**LAND USE APPLICATION SUMMARY**

*Property Location:* 3041 Holmes Avenue S  
*Project Name:* 3041 Holmes Avenue S  
*Prepared By:* [Kimberly Holien](#), Senior Planner, (612) 673-2402  
*Applicant:* Jim Graves  
*Project Contact:* Pete Keely, Collage Architects  
*Request:* To construct a six-story, mixed-use building with nine dwelling units  
*Required Applications:*

<b>Site Plan Review</b>	For the construction of a six-story, mixed use building with nine dwelling units.

**C-5.0**

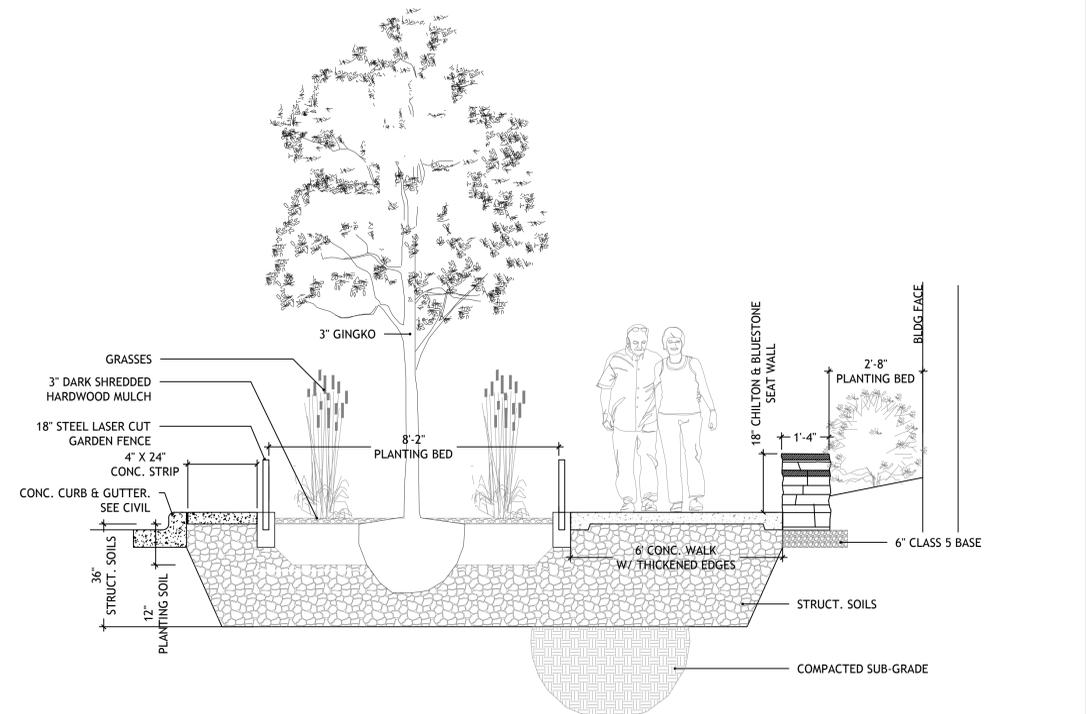
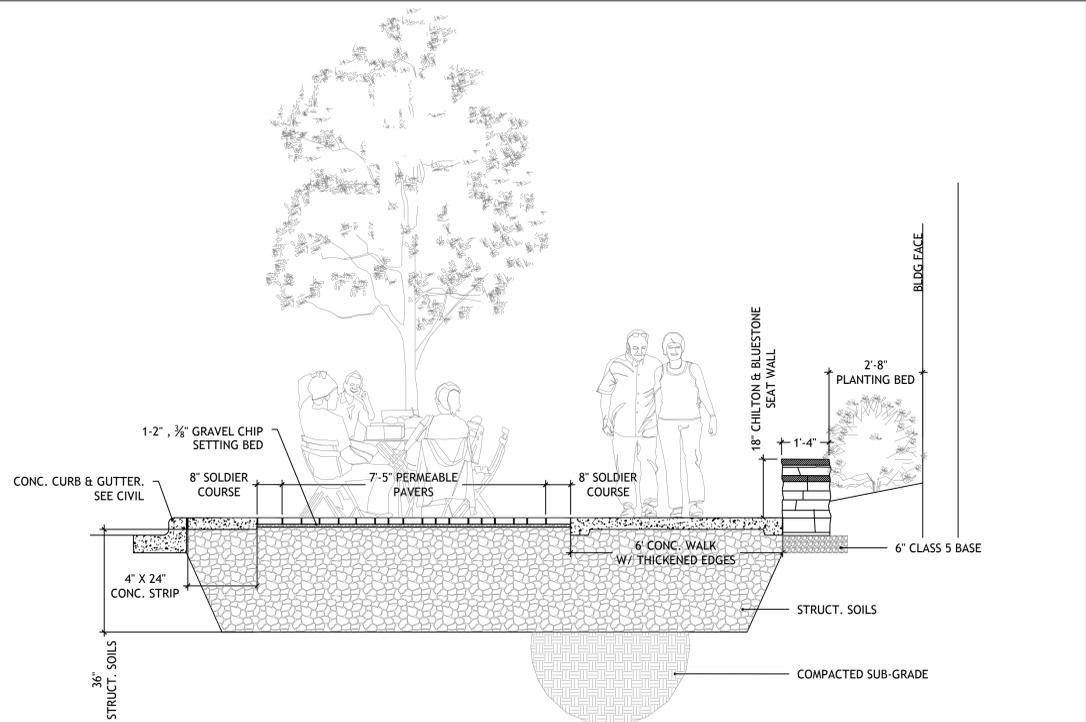
- The site plan includes notes related to the proposed curb cut along Holmes Ave. S. that are incorrect and do not follow Minneapolis standards. Truncated domes are not to be installed on either side of drive approach, and grades on the sidewalk at the drive approach shall not be depressed. All driveway aprons shall be designed and constructed to City standards. All driveway aprons shall be shown graphically correct on all related plan sheets. For detailed information related to City of Minneapolis standard specifications, details, and standard plates refer to the following: <http://www.minneapolismn.gov/publicworks/plates/index.htm>. The Site plan does include all of the correct City Standard plates (see Sheet C-5.0); all related plan sheets shall reference the standard plates on Sheet C-5.0.

A200

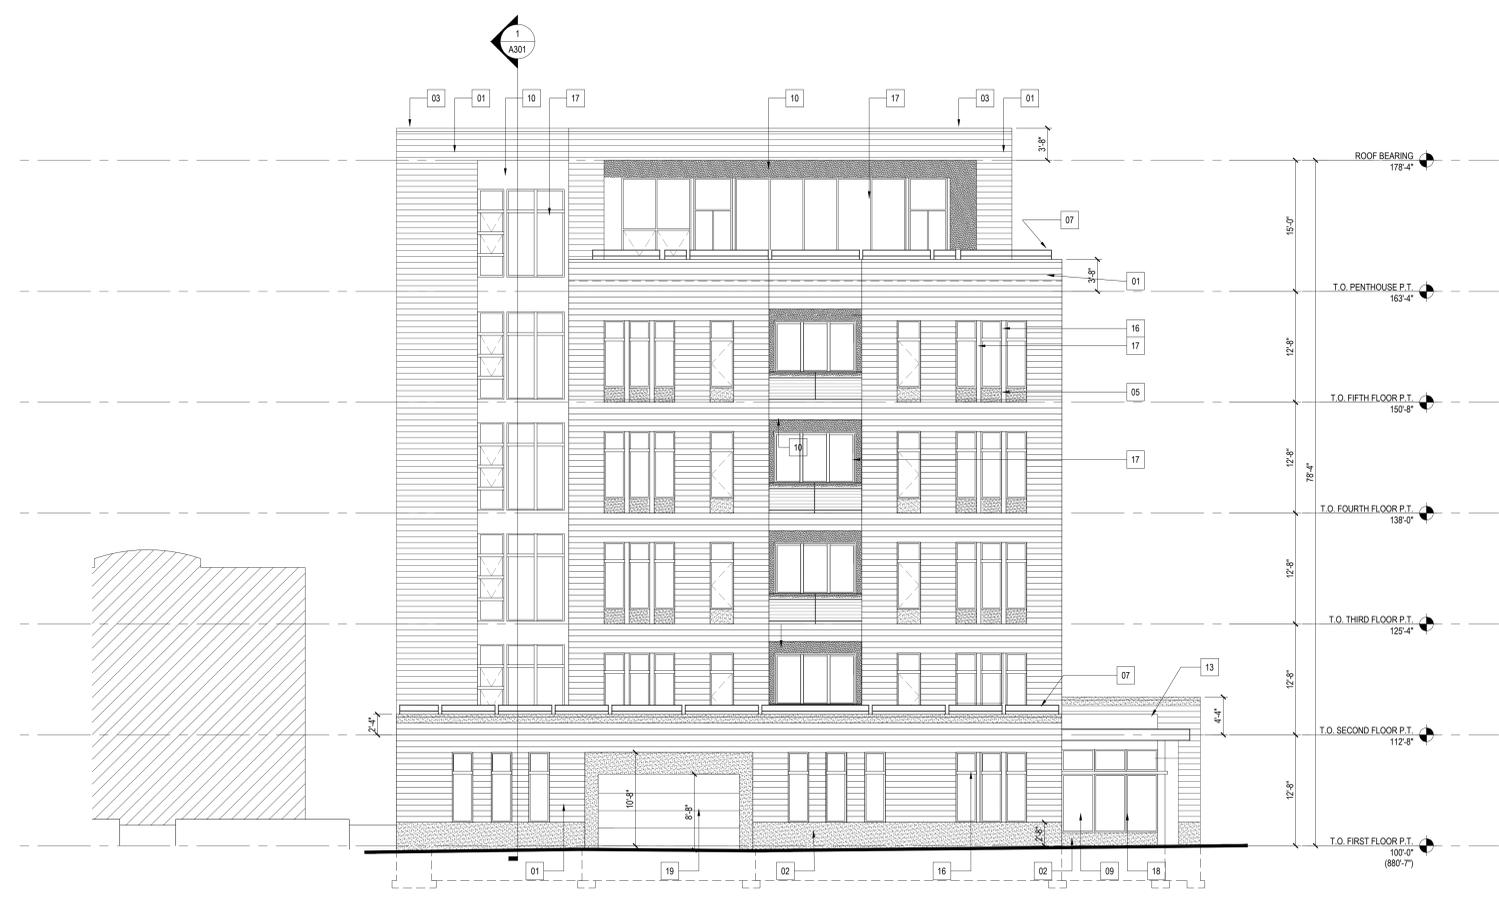
- Site Plan Review
  - Staff recommends adding windows to the west elevation to achieve 40 percent. Please note that windows are measured between two feet and 10 feet above grade.

A201

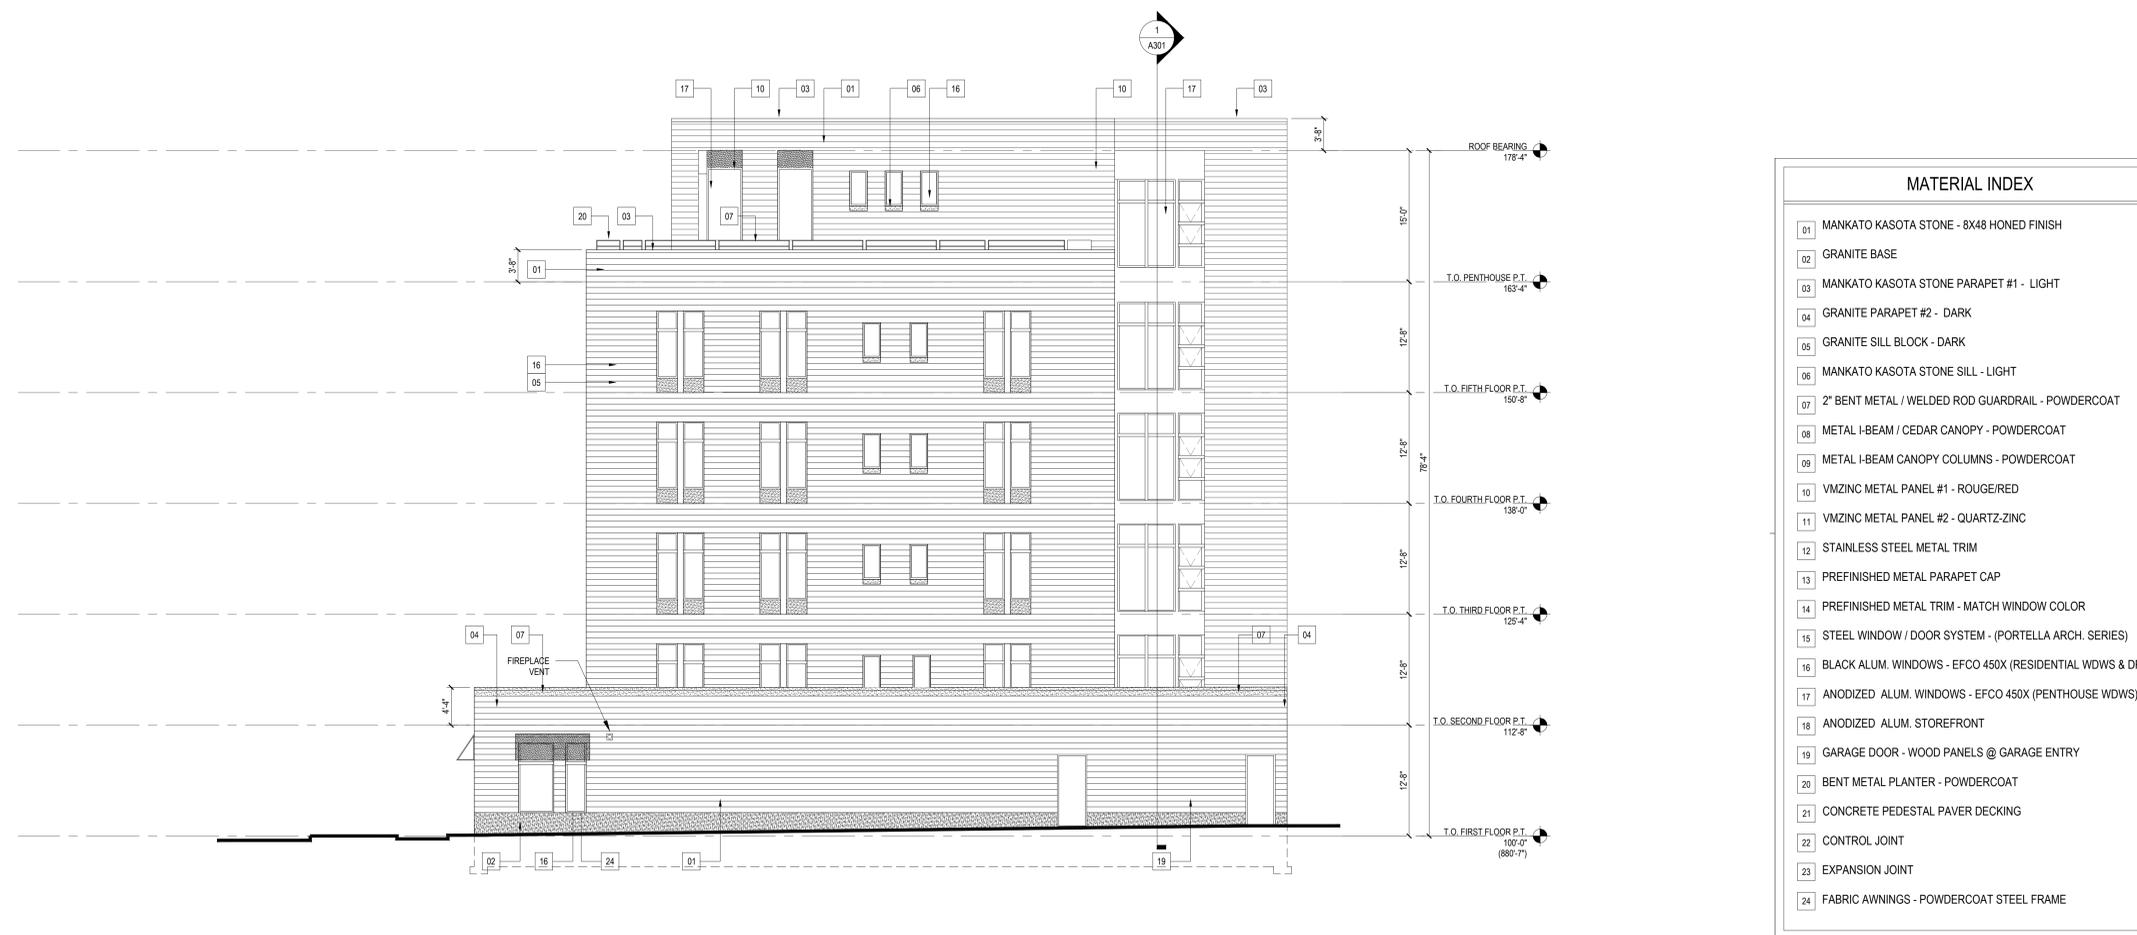
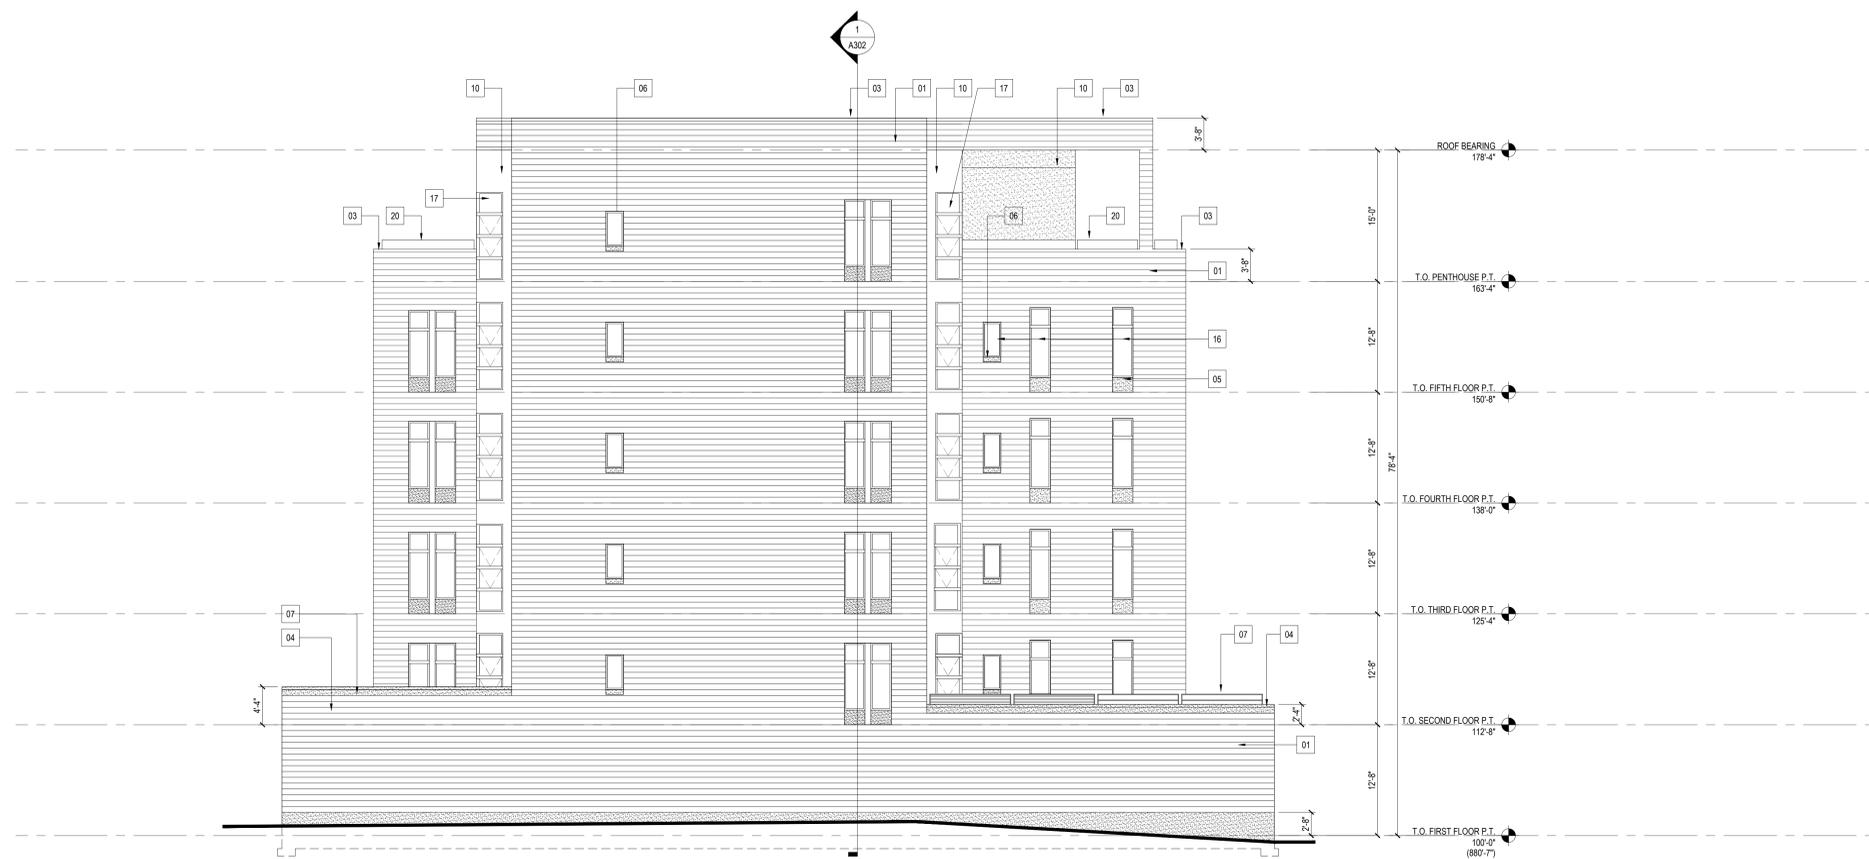
- **Blank walls.** The building contains of blank wall in excess of 25 feet on the first floor of the north elevation. Alternative compliance is requested. Staff recommends granting alternative compliance in this location. The primary exterior material is a high-quality stone veneer. Requiring a material change in this location may detract from the intent of the architecture and the overall design of the building. Tall plantings are provided along this section of blank wall to provide visual interest and soften the overall appearance.
